SECY-98-015

SUBJECT: FINAL GENERAL REGULATORY GUIDE AND STANDARD REVIEW PLAN
FOR RISK-INFORMED REGULATION OF POWER REACTORS

**AN APPROACH FOR USING PROBABILISTIC RISK ASSESSMENT IN
RISK-INFORMED DECISIONS ON PLANT-SPECIFIC CHANGES
TO THE CURRENT LICENSING BASIS**

Figure 3 - Acceptance Guidelines* for Core Damage Frequency (CDF)

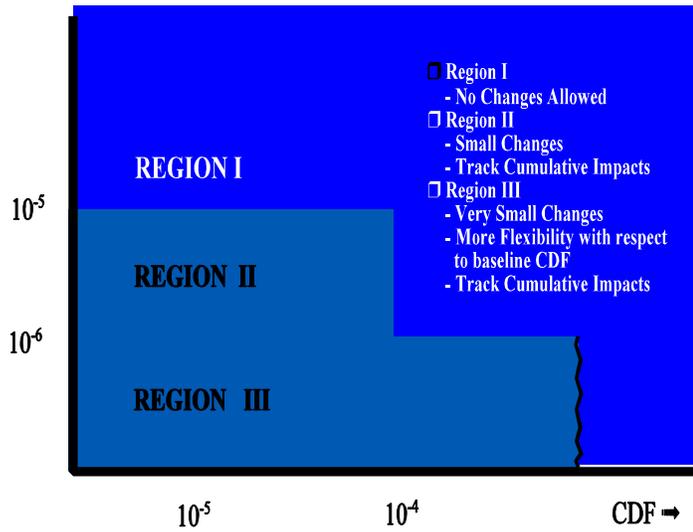
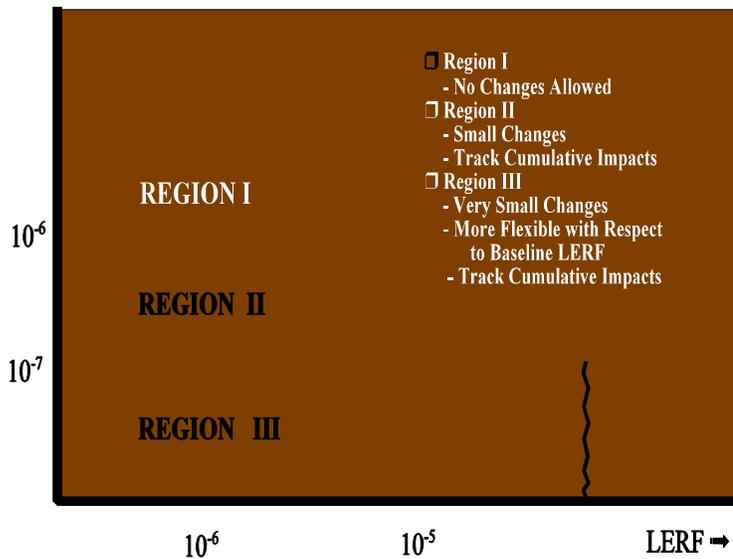
Resolution: Section 2.4.2.2, "Acceptance Guidelines," addresses the treatment of small increases in risk using the metrics of CDF and LERF. As noted in the discussion for Issue Number 1, this section has been revised and now includes a special category of application in which the estimated level of CDF/LERF increase associated with the application is sufficiently low such that, in general, program changes associated with this region may be permitted without a detailed assessment of the baseline CDF/LERF. This category is displayed in Figures 3 and 4 of Section 2.4.2.2.
